# CITY OF KIRKLAND

98<sup>TH</sup> AVE NE PRESERVATION  
JOB NO. 06-20-PW FEDERAL AID NO. STPUL-2201(010)

## ADDENDUM No. 1 TO THE PLANS, SPECIFICATIONS, PROPOSAL AND CONTRACT

Issued This Date: Tuesday, March 16, 2021  
Bid Opening: **Unchanged – March 22, 2021**  
Place of Opening: City Hall, Council Chambers, posted online

BRIDGE PAVING TRAIN

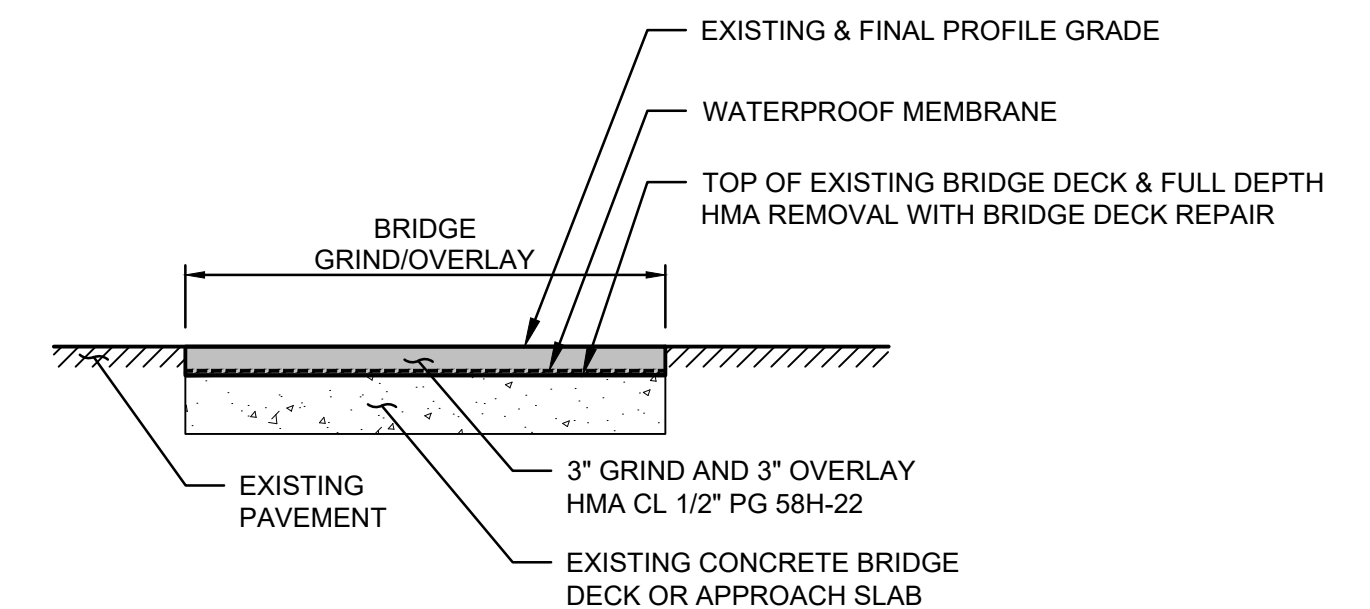
3. The Bridge Paving Train on BP-01 (sheet 19) shows the minimum spacing L0 between the HMA paver and the haul truck at 15'-0". This L0 spacing must be zero in order to transfer HMA mix to the paver.

Description: Plan Sheet 19 Bridge Plan and Details,

DELETE Plan Sheet 19 Bridge Plan and Details and REPLACE with enclosed Plan Sheet 19 Bridge Plan and Details.

03/16/21	ADDENDUM 1 - CLARIFIED L0 DIMENSION	ERP	BDC
DATE	NO. REVISION	BY
